# UNITED STATES PATENT AND TRADEMARK OFFICE

APPLICATION NO.	FILING DATE	FIRST NAMED INVENTOR	ATTORNEY DOCKET NO.	CONFIRMATION NO.
10/016,051	12/06/2001	Yoshitaka Mishima	SHC0162	6019

**Office Action Summary**

**FIG. 1*****Claim Rejections - 35 USC § 103***

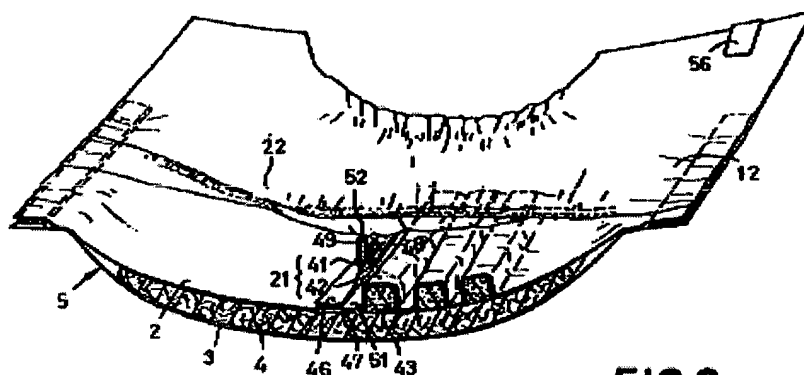
Regarding claim 2, Mishima *et al.* teach skin-contactable sheets (22) which comprise a pair of belt-shaped strips spaced apart from and opposed to each other in said transverse direction and respectively extending along said transversely opposite side edge portions (13) of said undergarment (1) in said longitudinal direction (C-C) so that said skin-contactable surface (2) inclusive of said liquid-absorbent panel (4) is partially exposed between the skin-contactable sheets (22)(see Fig. 1, below).

**FIG.2**

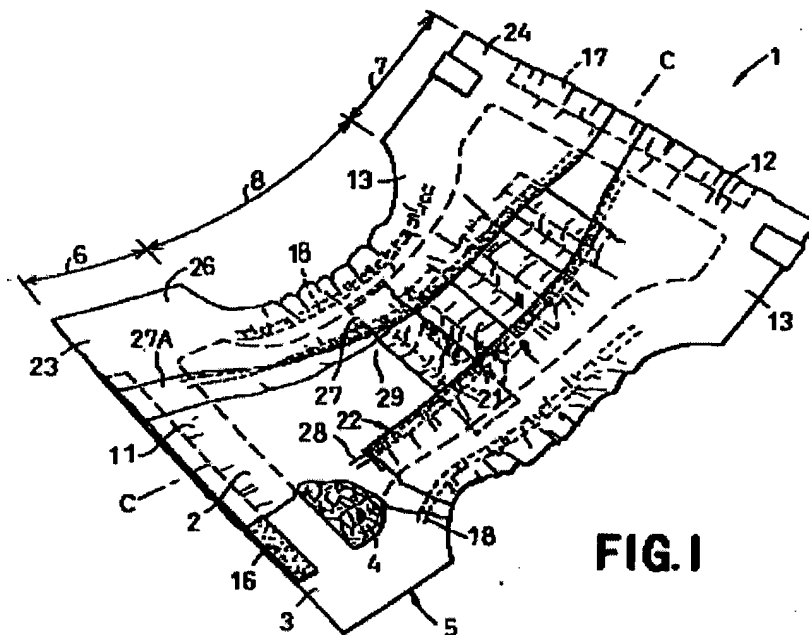
said skin-contactable surface (2) of said undergarment (1) being provided with regions (27) in which said skin-contactable sheets (22) are absent so that said skin-contactable surface (2) inclusive of said liquid-absorbent panel (4) is partially exposed in said regions (27) in which said skin-contactable panels (22) are absent (see Fig. 2, below).
